**Case No./Name:** PRD24-01 SAILOR'S LANDING  
**Meeting Date:** August 1, 2024  
**Request:** Planned Residential Development approval for a 226-site residential development.  
**Recommendation:** PRD24-01 Approval with conditions

**Proposed use:** A 226-unit planned residential development

### CHANGES FROM PREVIOUS PLAN

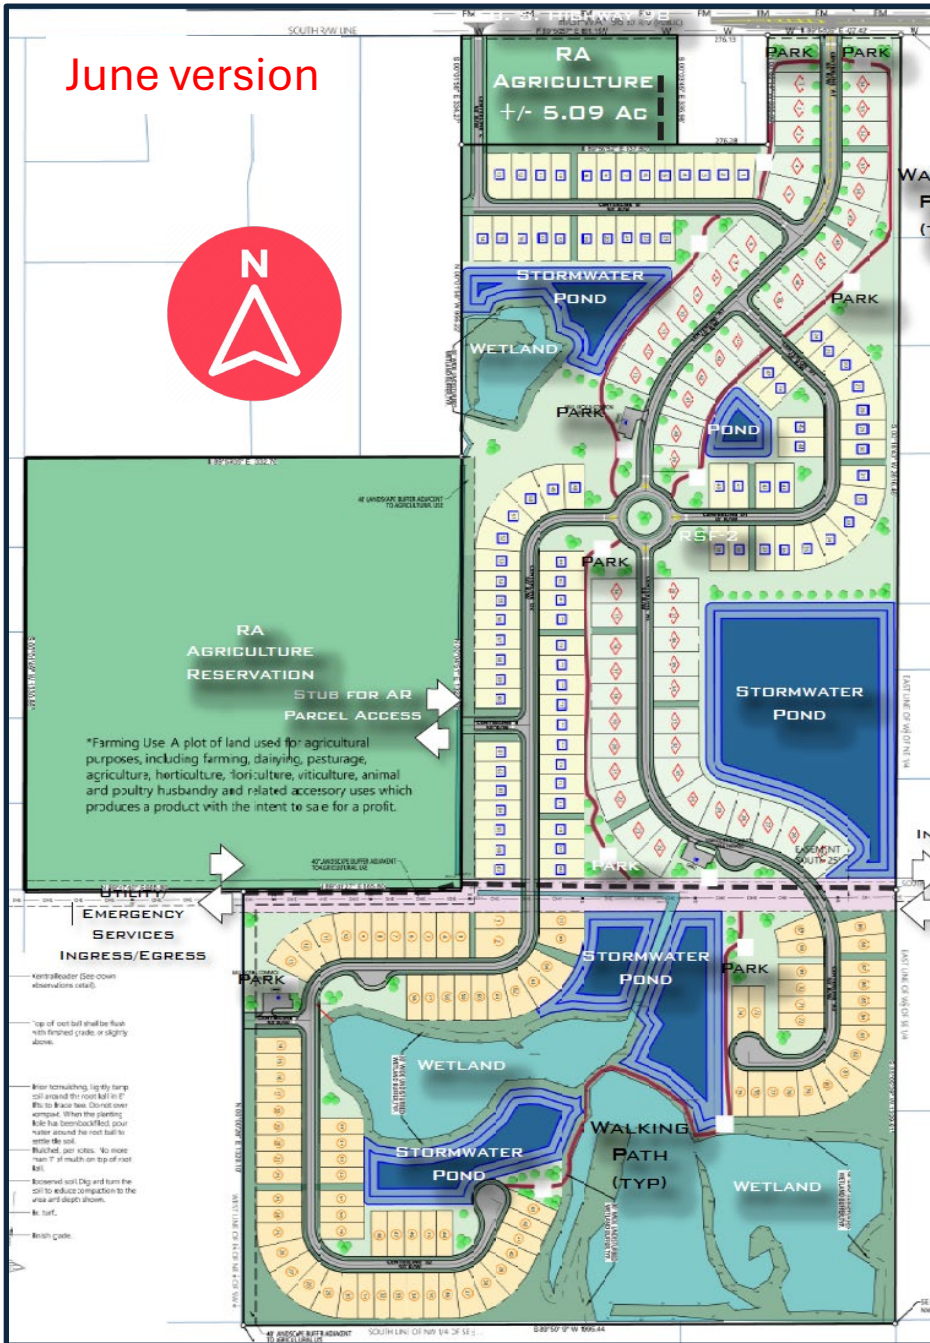
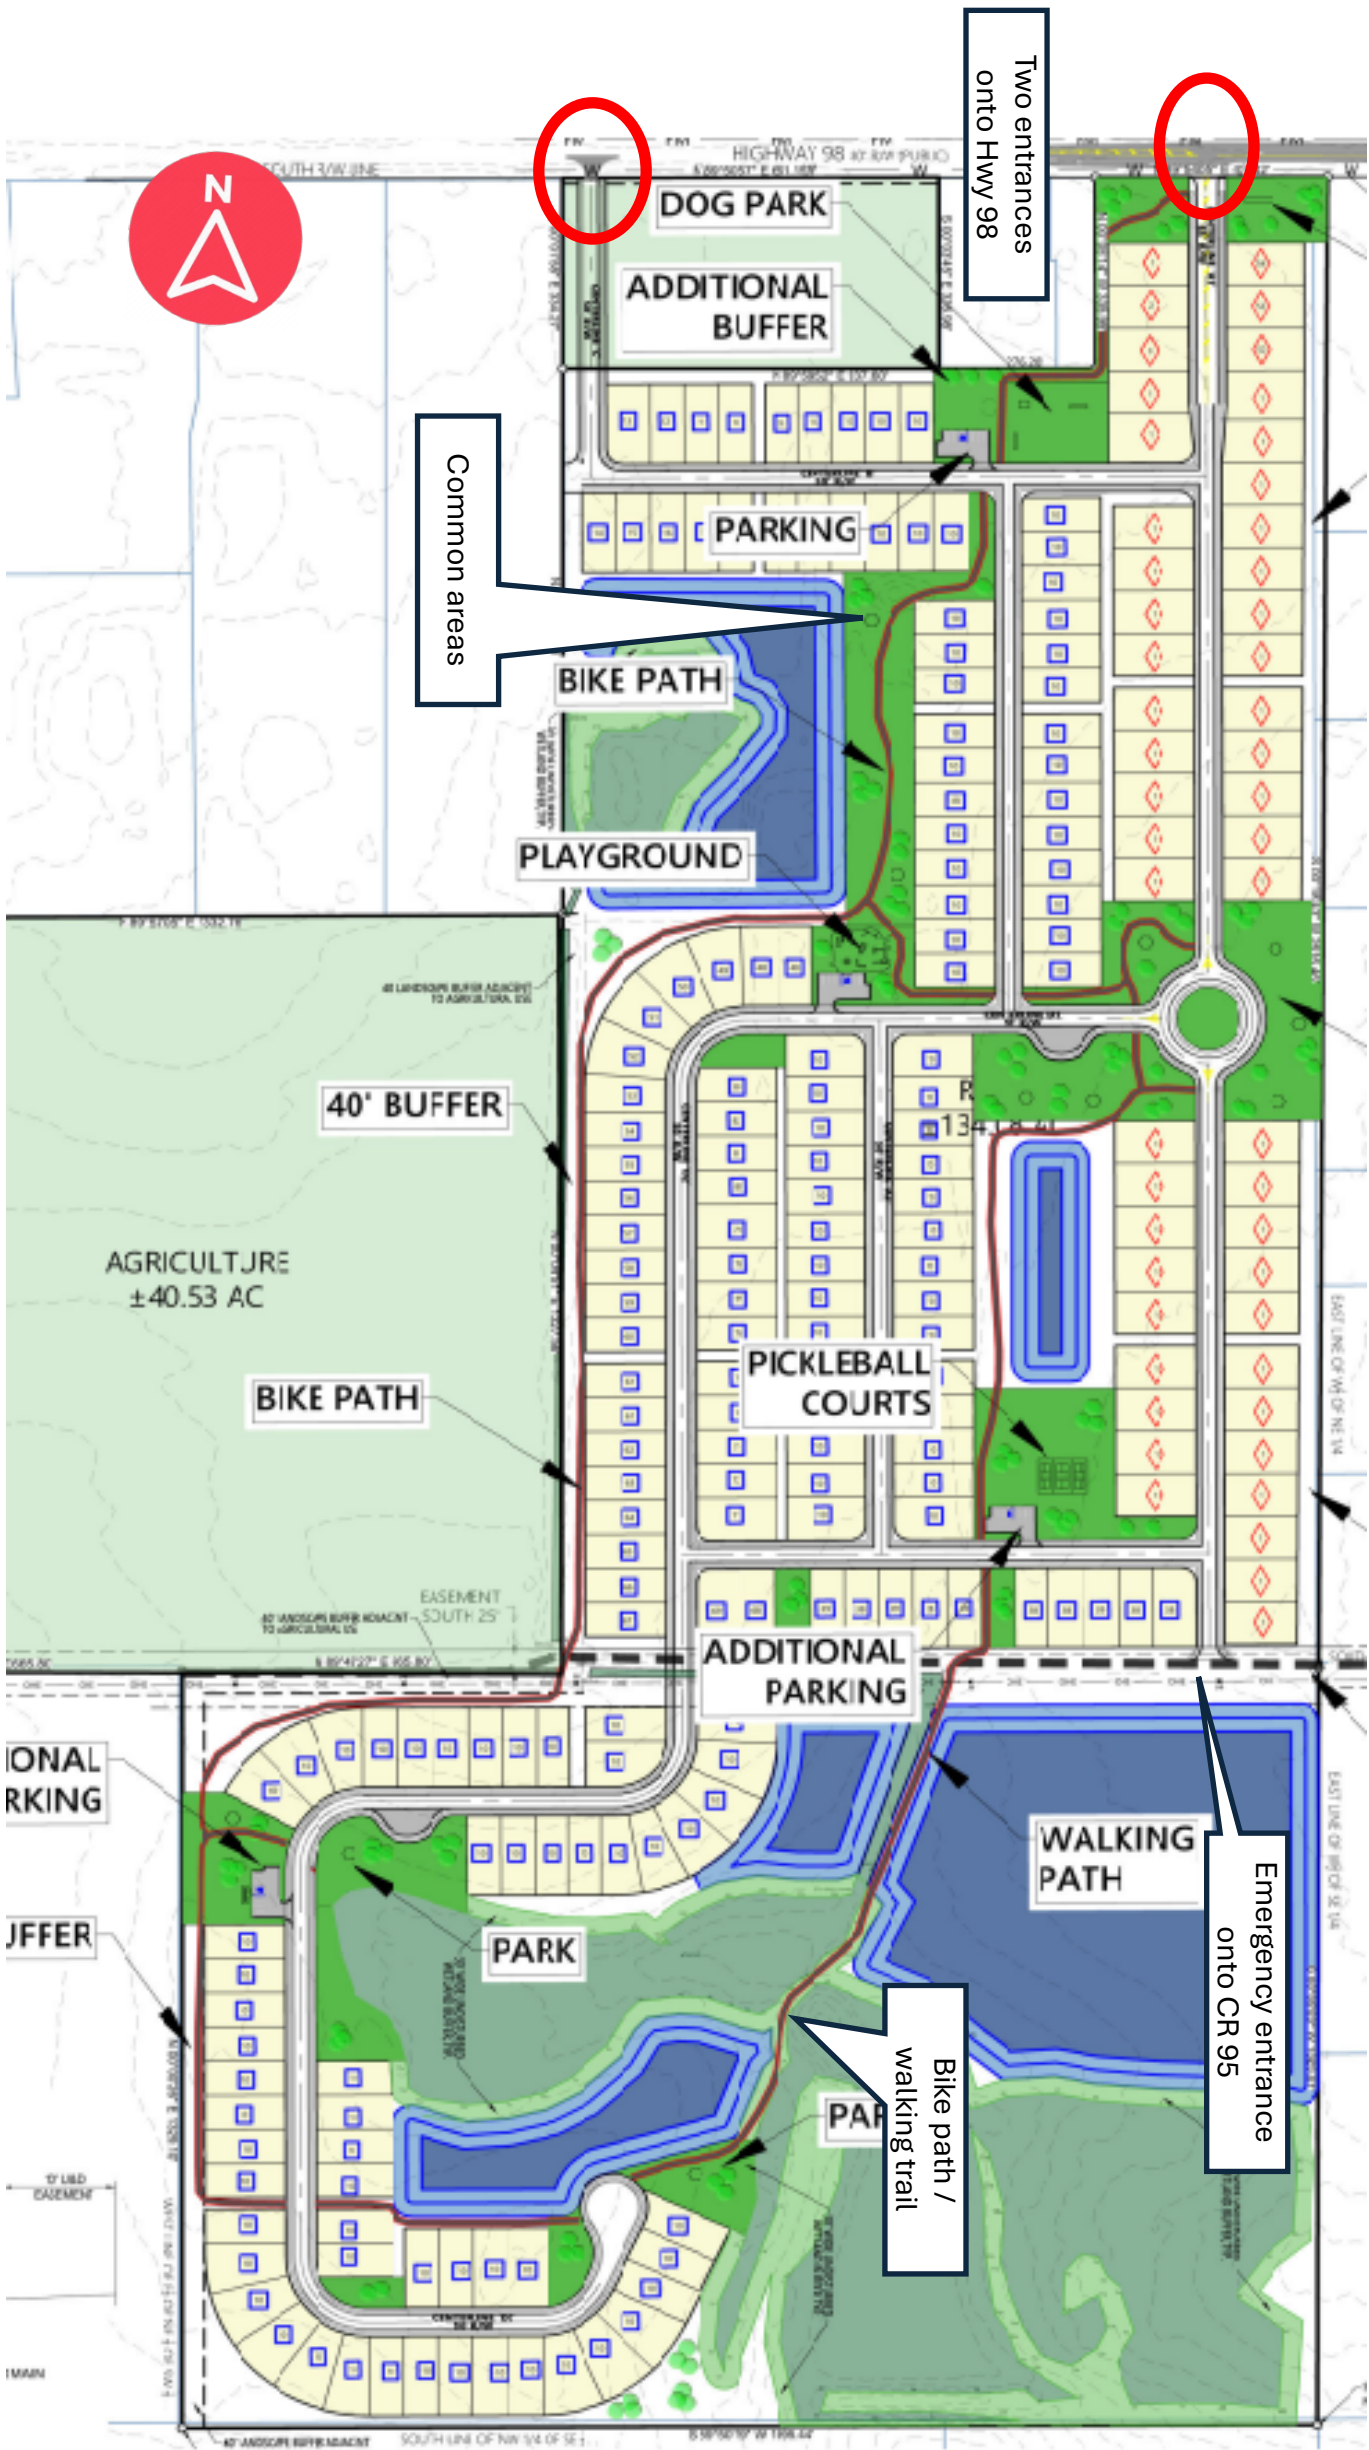
1. Active open space is more accessible but has been reduced by 6.1 acres. It still meets the minimum requirements.
2. The smallest lots, 50 ft wide, have been removed. The number of lots remains the same.
3. The landscape plan has been accepted and details about amenities have been added (pickleball courts, playground, dog park, pavilion).
4. Road circulation has improved with multiple routes from north to south.

## Bike path and wetland buffer

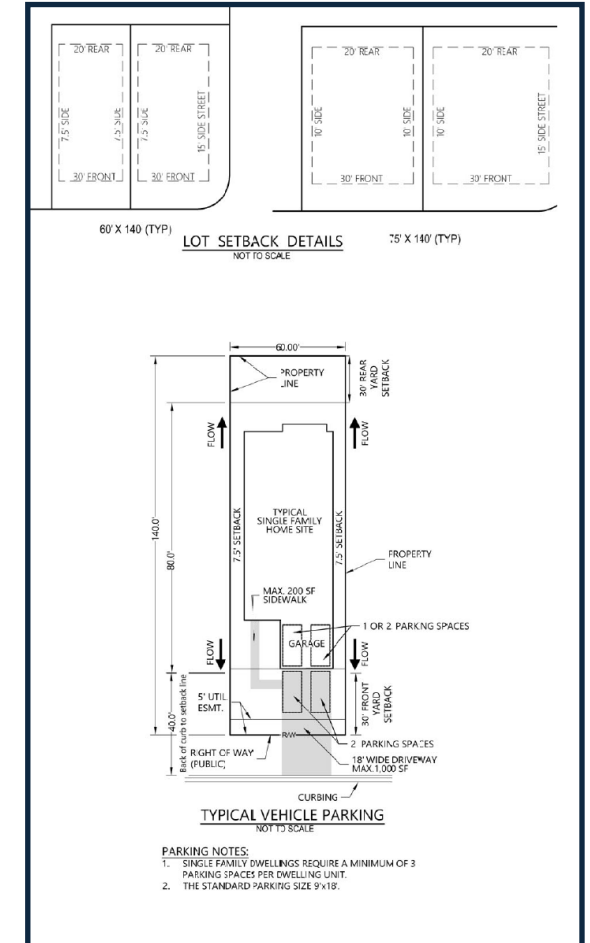
- A bike path appears to encroach into the required 30 ft non-disturbed wetland buffer. This will require a variance from the Board of Adjustments #2. If the variance is denied, the path must be relocated.

5. The agriculture parcel has been restored to the site plan since the initial staff report was written.
6. A bike path appears to encroach into the required 30 ft. non-disturbed wetland buffer. This will require a variance from the Board of Adjustments #2. If the variance is denied, the path must be relocated.

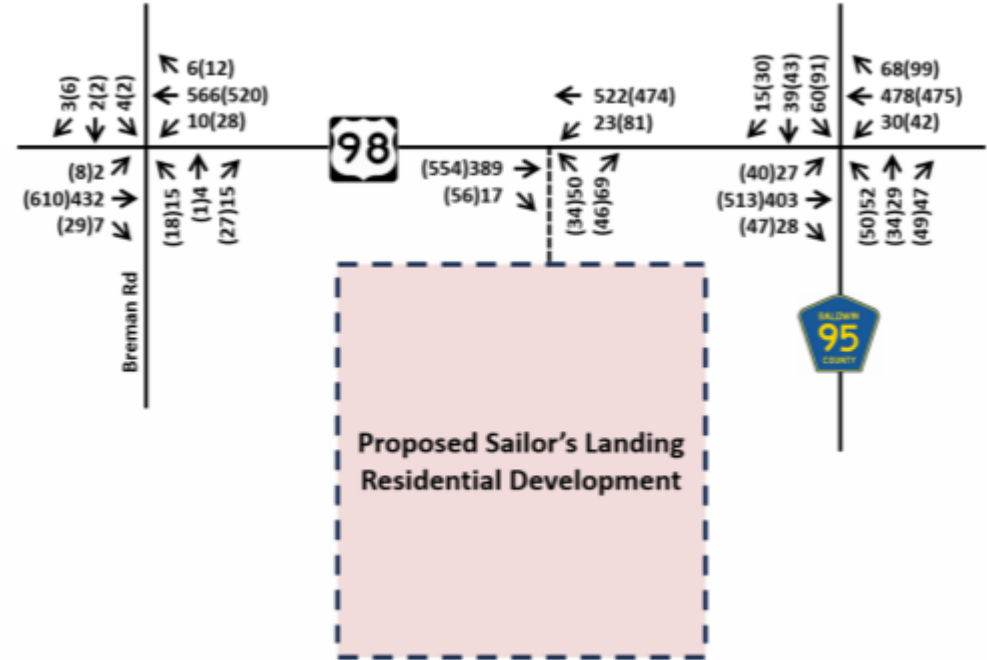
5. Traffic study – level of service (LOS) for two intersections included in the study. For preliminary plat review, the TIS must be revised to show 2 entrances onto Hwy 98.

The current TIS recommends left and right turn lanes at the entrance (one entrance shown but 2 are required). Staff defers to the Highway Dept. and ALDOT to determine what improvements will be required.

2. During preliminary plat review, the traffic study must be revised to show 2 entrances onto Hwy 98.
3. Provide revised utility letters that show approval for reduced utility setbacks. If setbacks must be increased, the amount of open space reflected on the site plan (33.95 ac) must be maintained.
